ADDENDUM TO THE CONTRACT

**Bartlett Regional Hospital (BRH)
Tomosynthesis Renovation
Contract No. BE17-032**

ADDENDUM NO.: ONE

DATE ADDENDUM ISSUED: October 20, 2016

FINAL ROOM PLAN

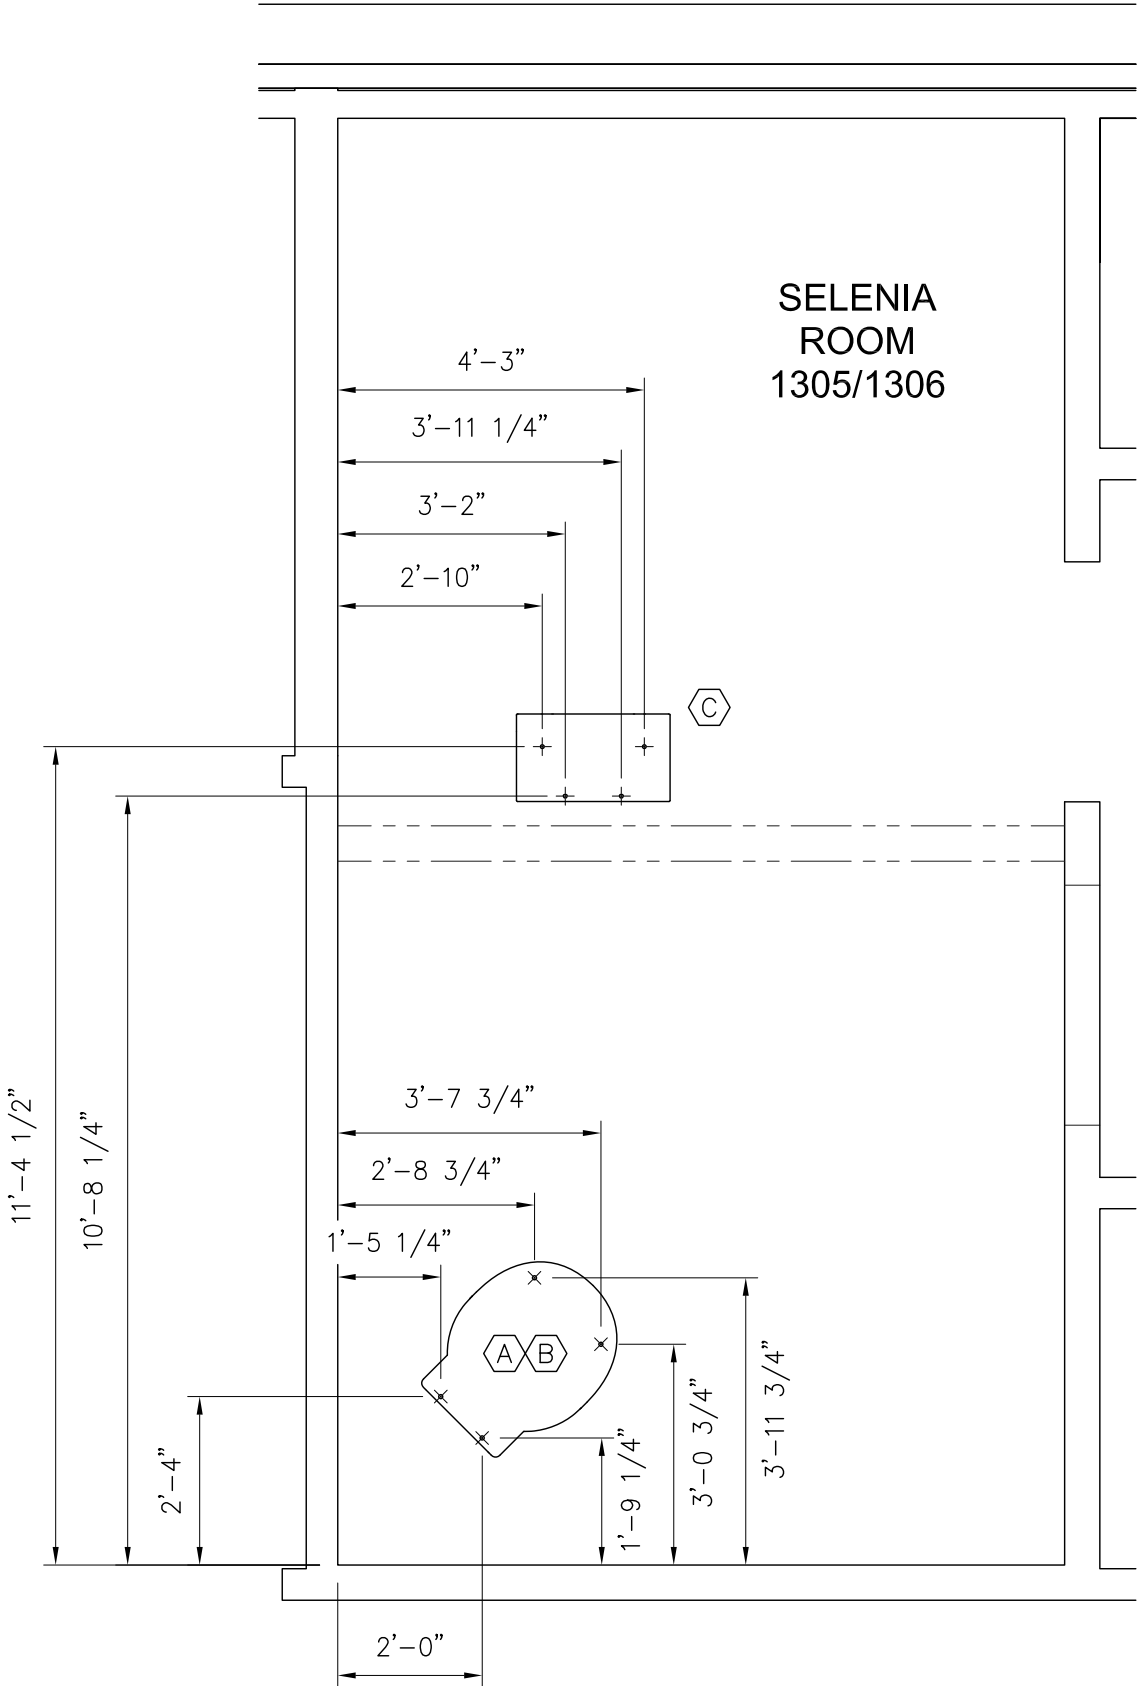
'SELENIA DIMENSIONS' EQUIPMENT PLAN
OPTION 1 SELECTED WITH REVISIONS.

NOTE:
THE AFFIRM DEVICE, AKRUS CHAIR AND SUROS DEVICE ARE ADDED. PRIOR TO INSTALLATION, THIS ROOM MUST BE TESTED FOR POTENTIAL ELECTROMAGNETIC INTERFERENCE.
